UNITED STATES PATENT AND TRADEMARK OFFICE

| APPLICATION NO. | FILING DATE | FIRST NAMED INVENTOR | ATTORNEY DOCKET NO. | CONFIRMATION NO. |
|--|-------------|----------------------|-------------------------|------------------|
| 10/734,540 | 12/12/2003 | Paul Yang | 14101 B | 9708 |

| Office Action Summary | Application No. 10/734,540 | Applicant(s) YANG ET AL. | |

DETAILED ACTION

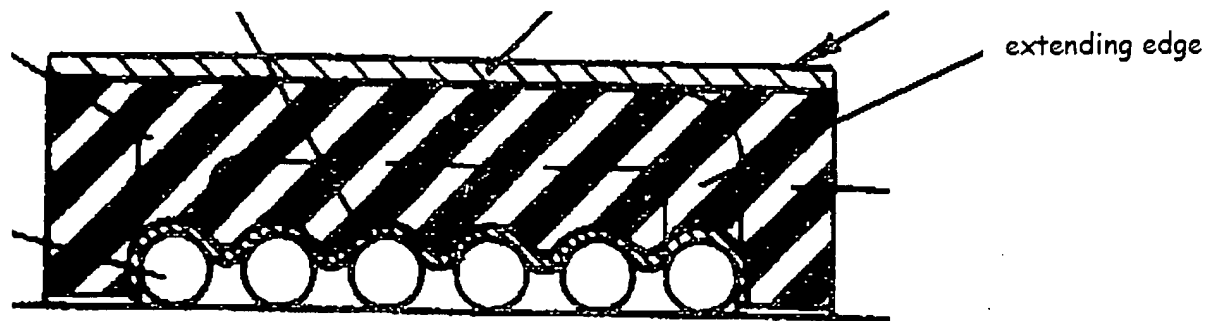
Lundgren discloses a reflow device for a ball screw provided with a recirculating path (6), capable of being fixed to a screw nut assembly and integrally combined with a screw nut, the reflow device including a hard portion (7) and a soft portion (5), the hard portion combined with the soft portion.

Lundgren does not disclose the reflow device wherein the rolling balls are surrounded by the soft portion.

Benton teaches of a reflow device wherein the rolling balls are surrounded by a soft portion (64) to create a low friction endless track for the balls to recirculate (Col 2, line 47-66).

It would have been obvious to one having ordinary skill in the art at the time the invention was made to modify the teachings of Lundgren and surround the reflow path with soft material to create a low friction endless track as taught by Benton.
